**Department of Energy**  
Richland Operations Office  
P.O. Box 550  
Richland, Washington 99352

15-ESQ-0001

**CLASS 1 MODIFICATIONS TO THE HANFORD FACILITY RESOURCE CONSERVATION AND RECOVERY ACT PERMIT (PERMIT), QUARTER ENDING SEPTEMBER 30, 2014**

In accordance with Permit Condition I.C.3, enclosed for your notification are the Class 1 modifications for the quarter ending September 30, 2014.

24590-LAW-VDCN-M-13-00001  
Page 6 of 6

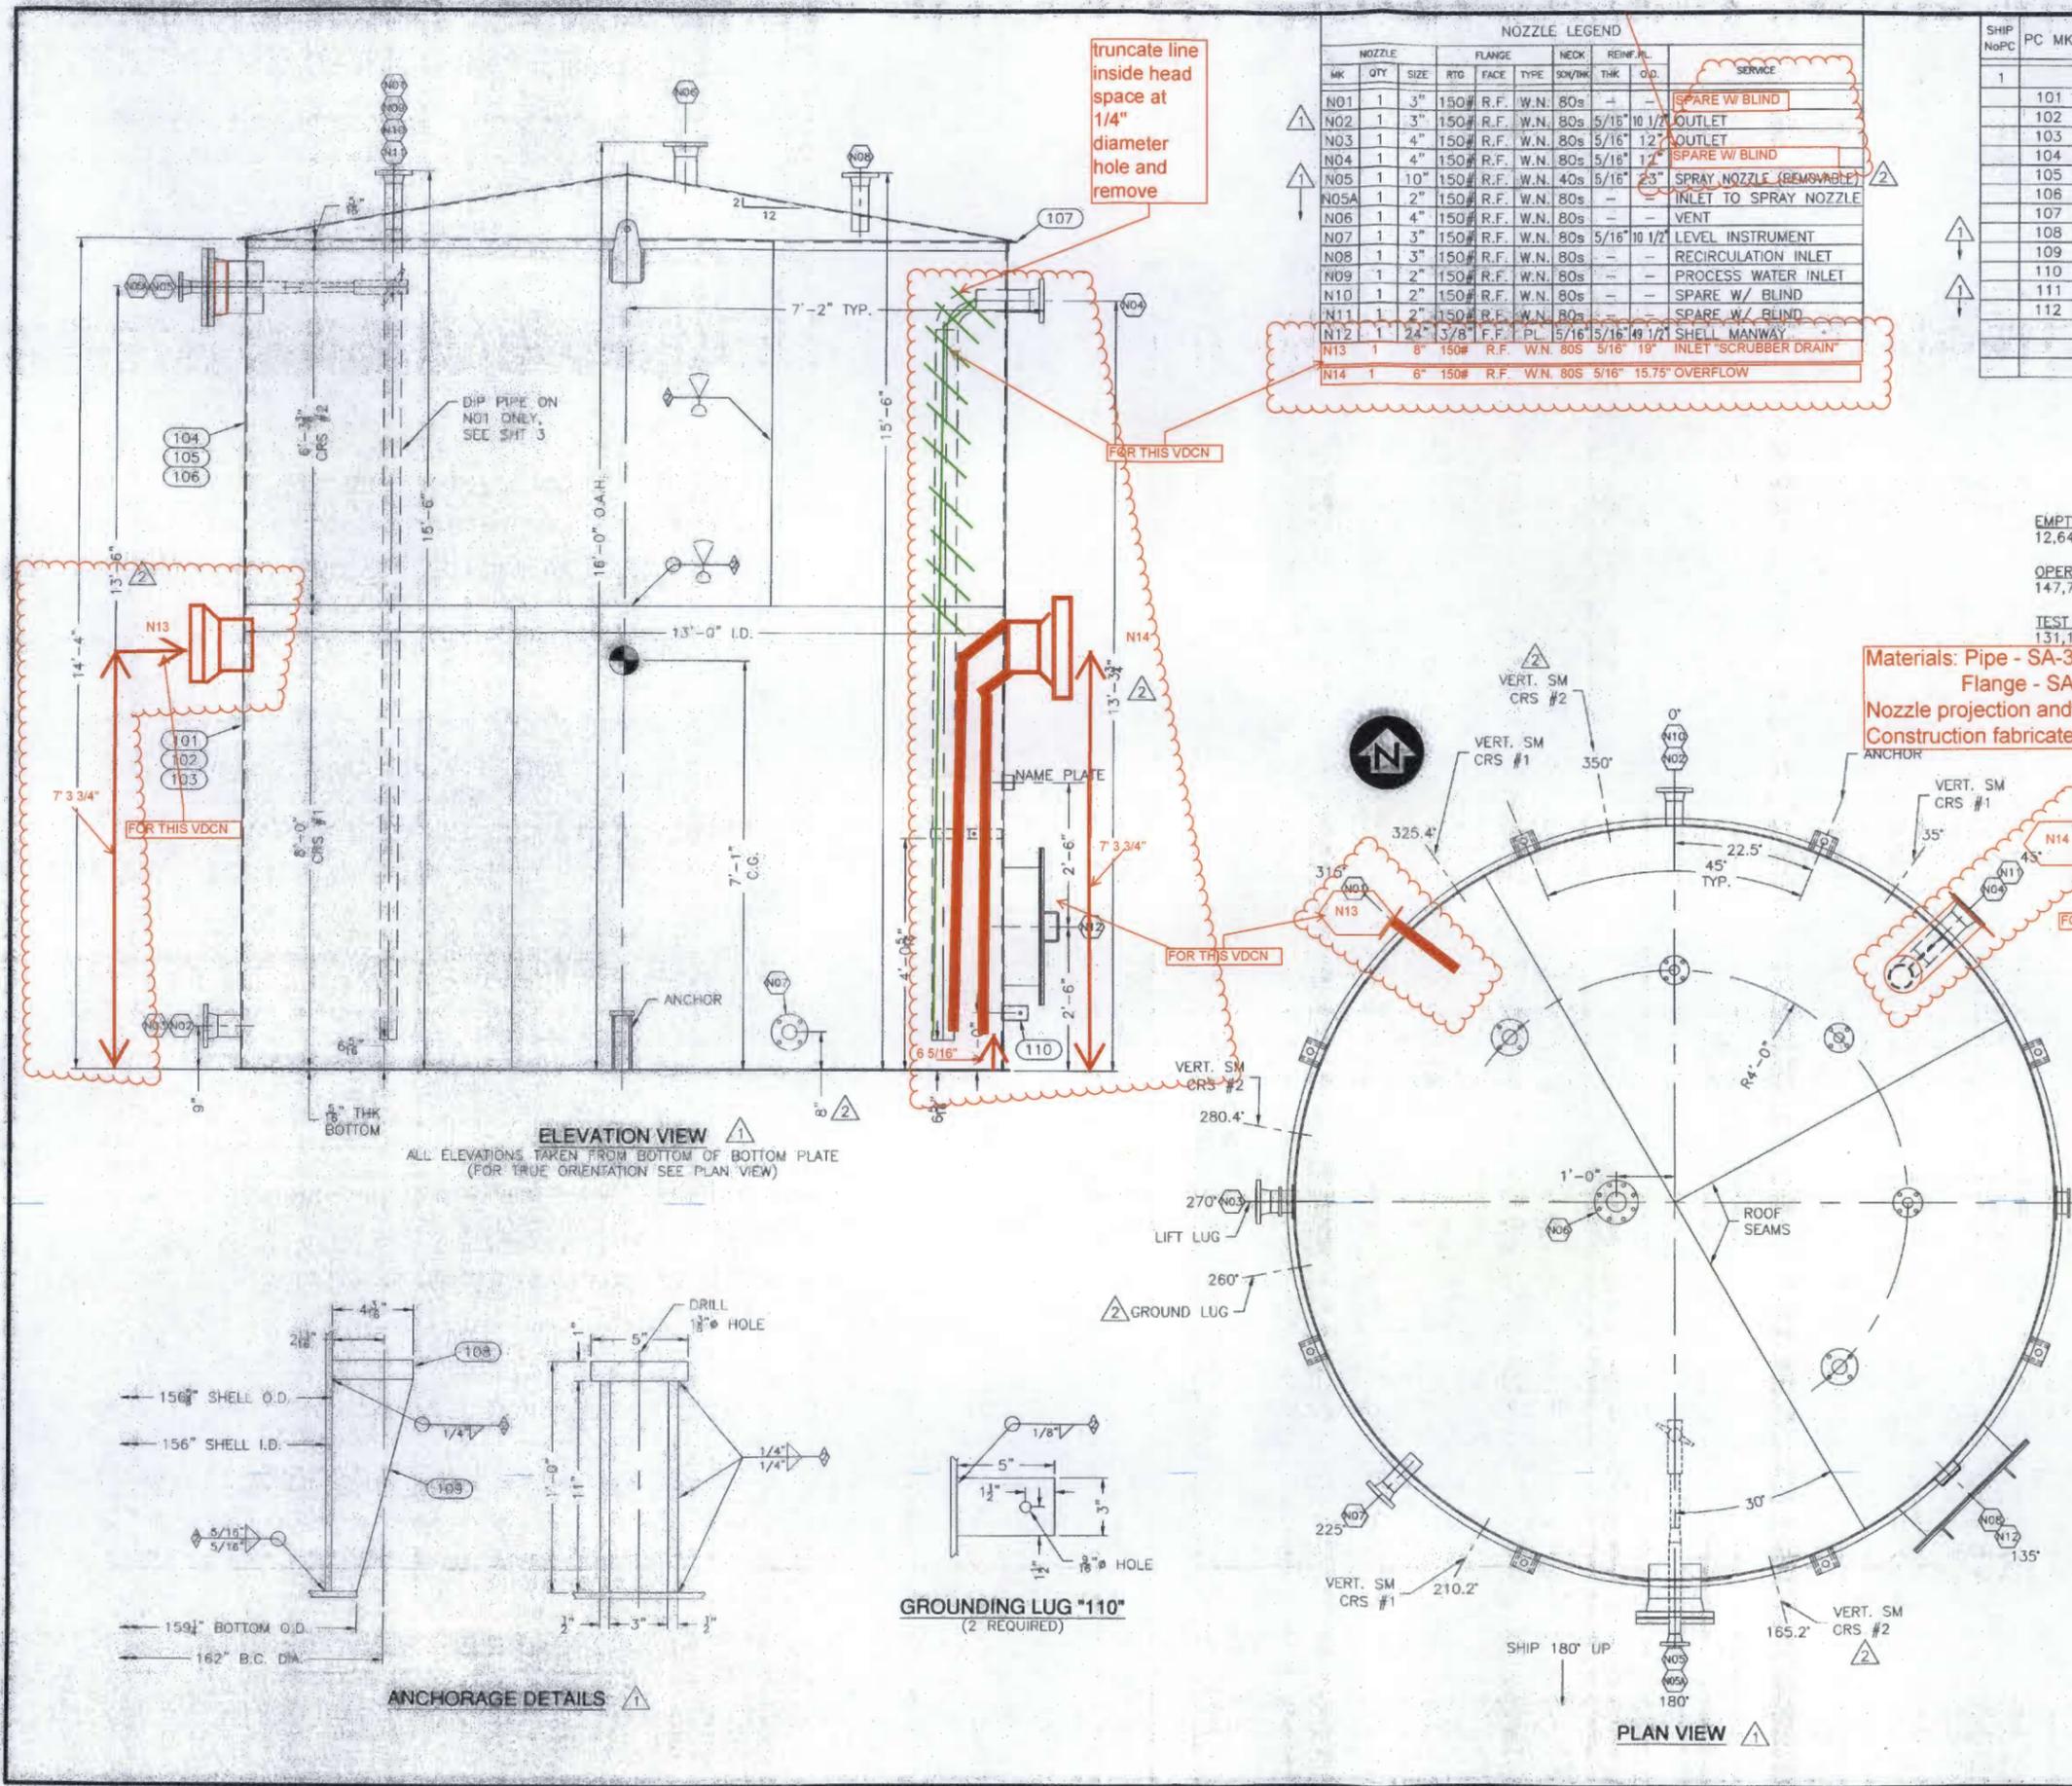
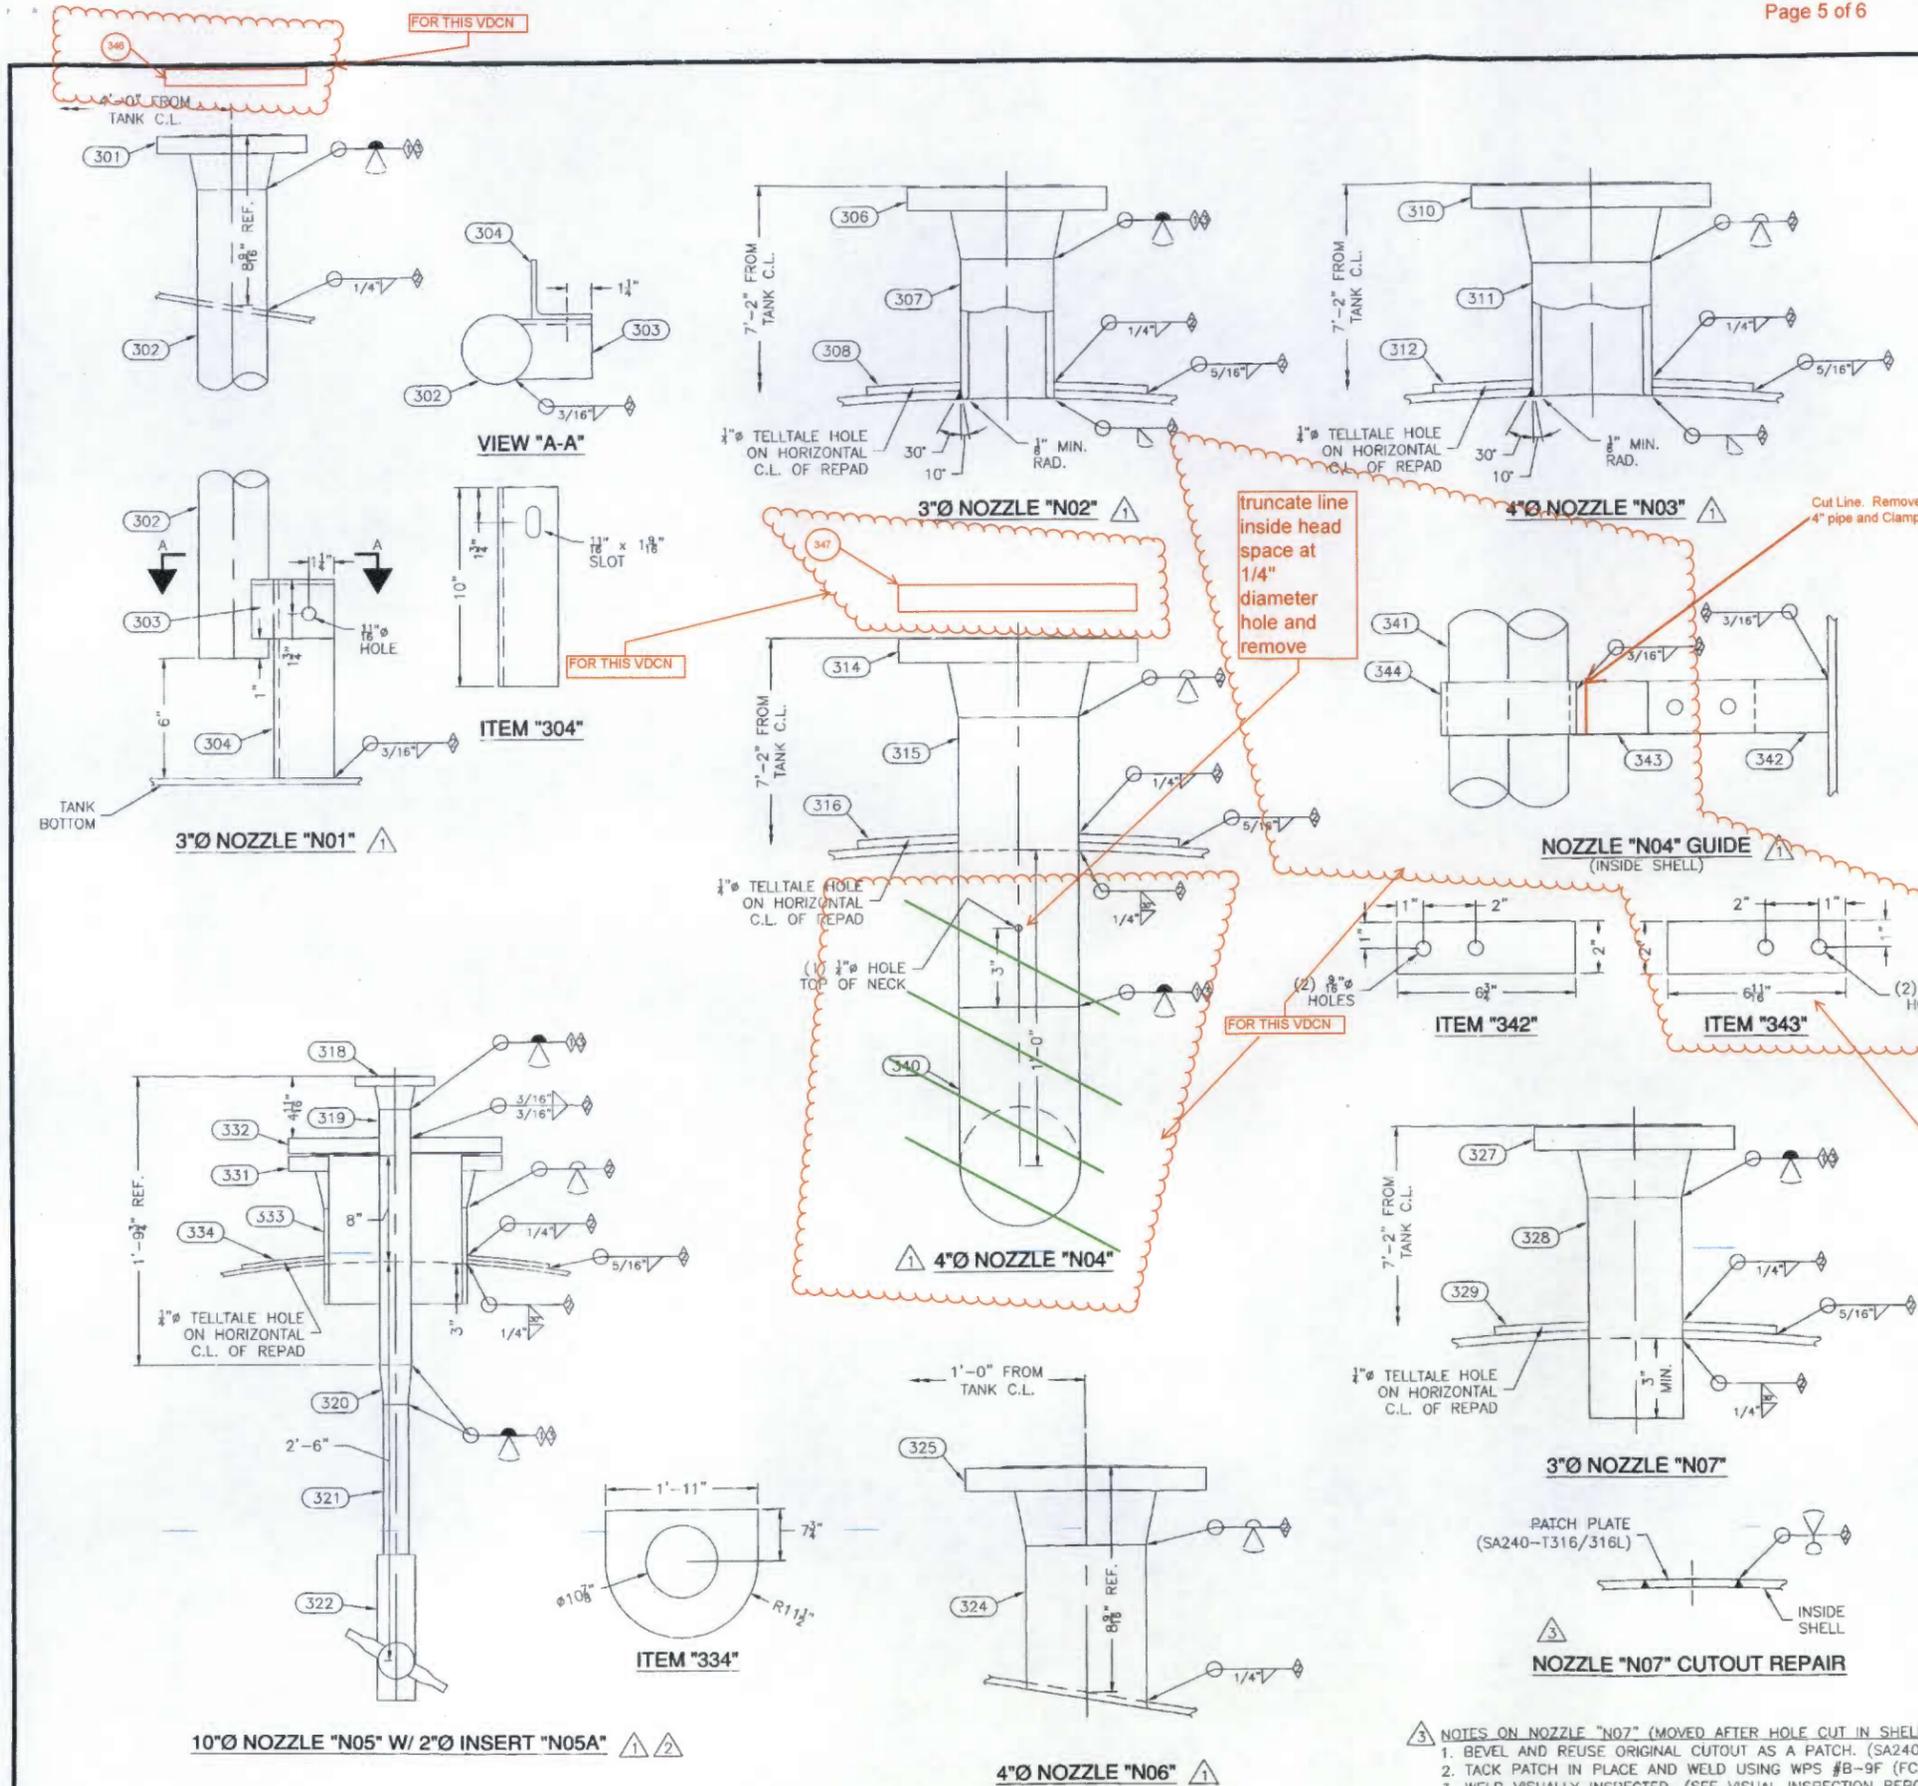
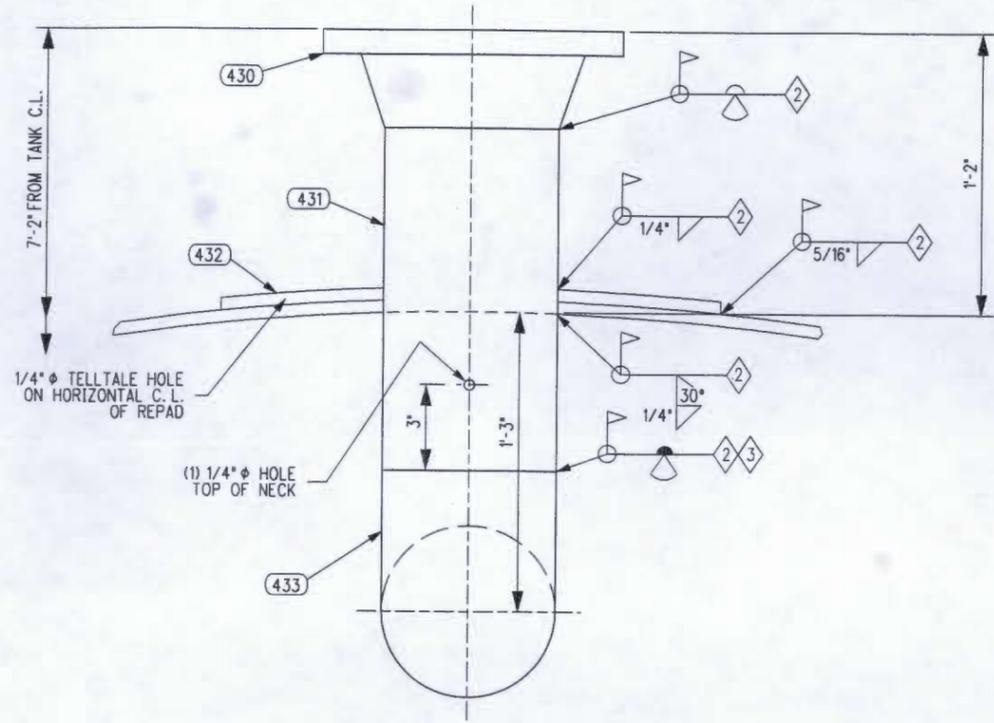
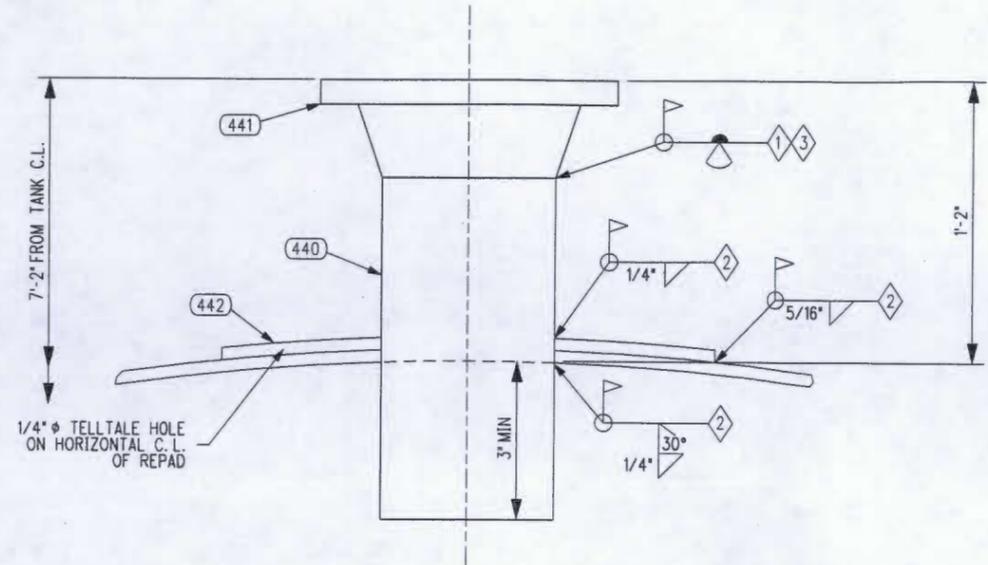
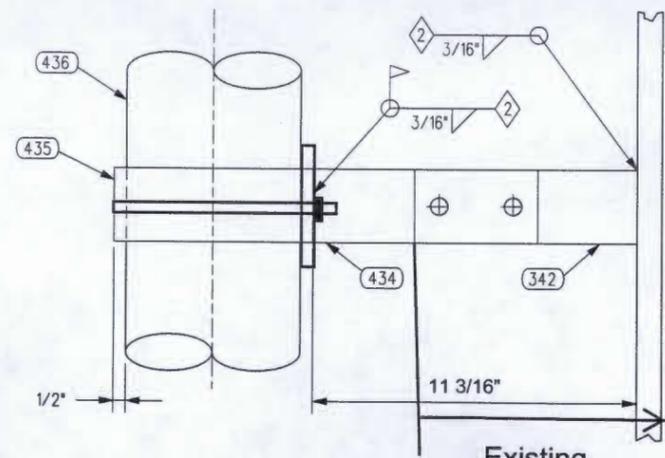
Remove Plate 343 and replace with plate 434 - see page 6 of 6.

- NOTES ON NOZZLE "N07" (MOVED AFTER HOLE CUT IN SHELL):
- BEVEL AND REUSE ORIGINAL CUTOUT AS A PATCH. (SA240-T316/316L)
  - TACK PATCH IN PLACE AND WELD USING WPS #B-9F (FCAW)
  - WELD VISUALLY INSPECTED. (SEE VISUAL INSPECTION REPORT)
  - WELD GROUND FLUSH ON INSIDE OF VESSEL AND DYE PENETRANT TESTED. (SEE LP TEST REPORT)
  - PMI PERFORMED ON WELD OF PATCH TO SHELL

Page 2 of 2: Hanford Facility RCRA Permit, Part III, Operating Unit 10, Waste Treatment and Immobilization Plant  
Submit update to P&ID 24590-WTP-M6-50-00002, Symbols and Legend drawing (Sheet 2 of 8) in Appendix  
7.2 of the Dangerous Waste Permit (DWP).

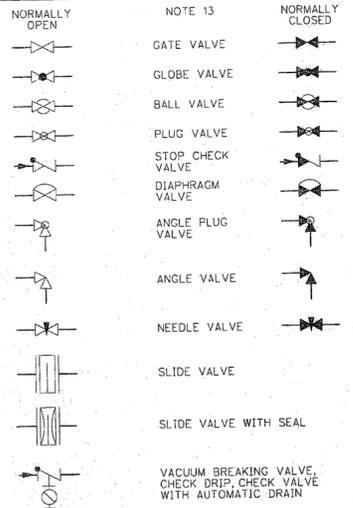
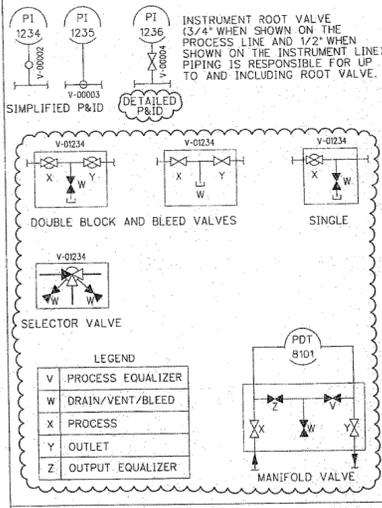
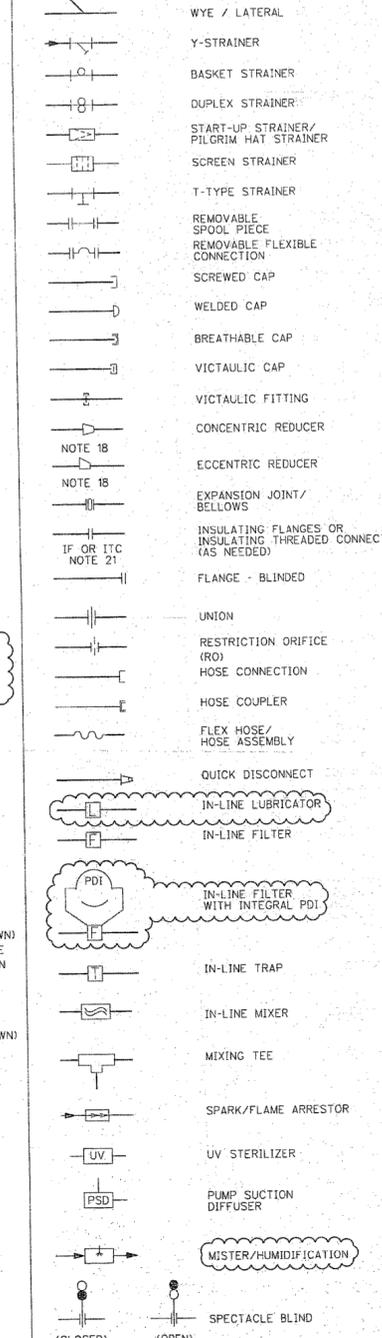
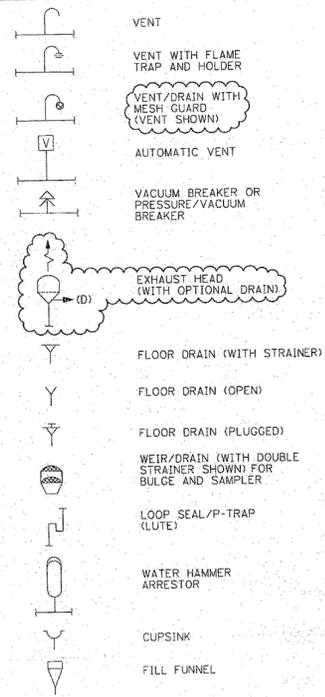
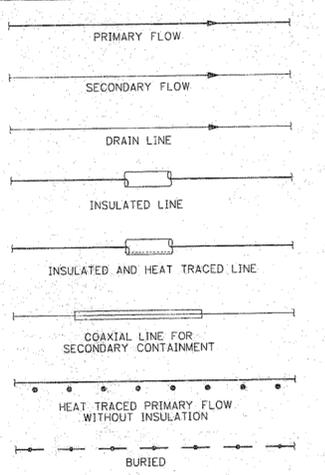
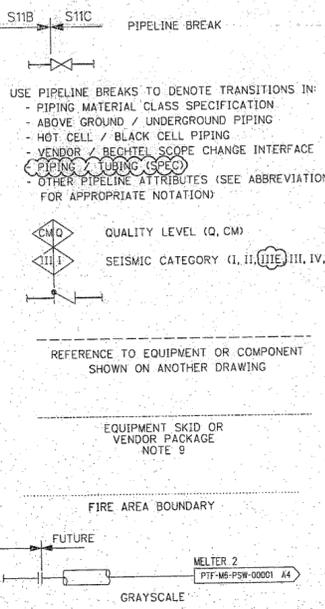
Piping & Instrumentation Diagrams, Appendix 7.2																						
Replace:	24590-WTP-M6-50-00002, Rev. 4	With:	24590-WTP-M6-50-00002, Rev. 5																			
WAC 173-303-830 Modification Class:	Class 1	Class 1 <sup>1</sup>	Class 2	Class 3																		
Please mark the Modification Class:	X																					
<p>Modification Approved/Concur: <input checked="" type="checkbox"/> Yes <input type="checkbox"/> Denied (state reason below)</p> <p><u>Reason for denial:</u></p>			<p>Reviewed by Ecology:</p> <div style="text-align: center; margin-top: 20px;">               _____              S. Dahl         </div> <div style="text-align: right; margin-top: 20px;">             9/18/14              _____              Date         </div>
